Infrastructure Report

Dundrum Central
Development

March 2022

Document No: 20.170 - RP – 01 PL4

Figure 2.10 – BM SuDS Layout drg C-1030

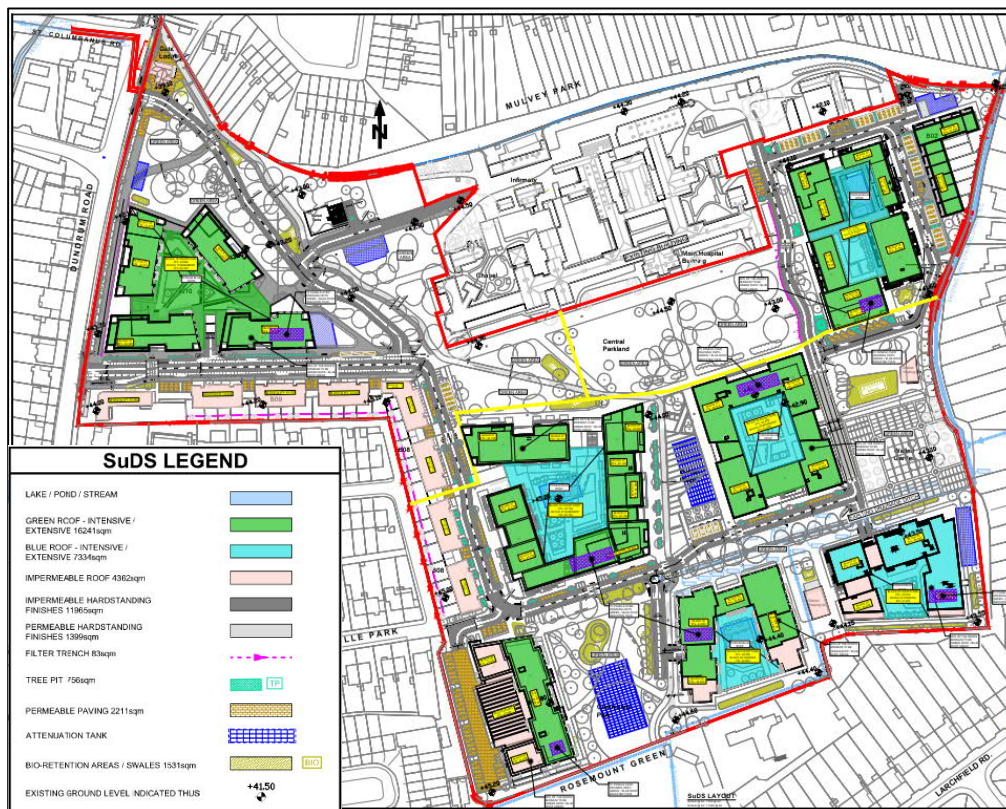
11. "Although the applicant has tabulated that the required volume can be intercepted/treated, they have not demonstrated that the entire area of the site is accommodated. As standard, the applicant is requested to show the options being proposed for interception and treatment with contributing areas on a drawing together with an accompanying text and tabular submission showing the calculations, to demonstrate that the entire site is in compliance with GDSDS requirements. The applicant should note that over-provision in one location does not compensate for under provision elsewhere. "

5	<p><u>Review of Drawing 1020/PL4 and 1030/PL3</u></p> <p>1 - a number of RC tanks are proposed which would not normally be considered acceptable but no other option may be available. However, H & J do not seem to be located under or within buildings</p> <p>2 - A small number of RG's appear to be connected directly to the sw network e.g.;</p> <ul style="list-style-type: none"> • Adjacent to s12.2. • Two road gullies at the BM-Road 2 entrance are connected directly to the to the sw network. Although only a small area could these be connected to a filter drain or tree pit? <p>3 - Road 2: from S1.8A to S1.11 - how is this road drained? No RG's or filter drain is shown. Also, there is a junction table which might interfere with the flow path. Raised speed tables are located in other areas</p>	<p>1 - Use of concrete tanks is subject to Planning Authority approval. BMCE to confirm that no other suitable alternatives are available, particularly with regard to tanks H & J which appear to be outside the building lines.</p> <p>2 - BMCE to review RG connections and connect to a SuDS feature where possible</p> <p>3 - BMCE to review all sections of road and confirm that adequate provision has been made for their drainage and that any new RG are connected to a SuDS feature.</p>	<p>1-Concrete tank H is an extension of the Block 10 basement and will need to remain a concrete tank. Tank J will be revised to a tank constructed with proprietary cellular units with a permeable lining. A low infiltration value has been used in the calculations (0.264m/hr - As per section 6.3 of Site Investigation).</p> <p>2 - All RG locations will be reviewed and addressed.</p> <p>3 - All RG locations will be reviewed.</p>	Accepted

BM Response: The requested information has been provided in this report and on the BM SuDS layout drawing, drawing no. C1030.
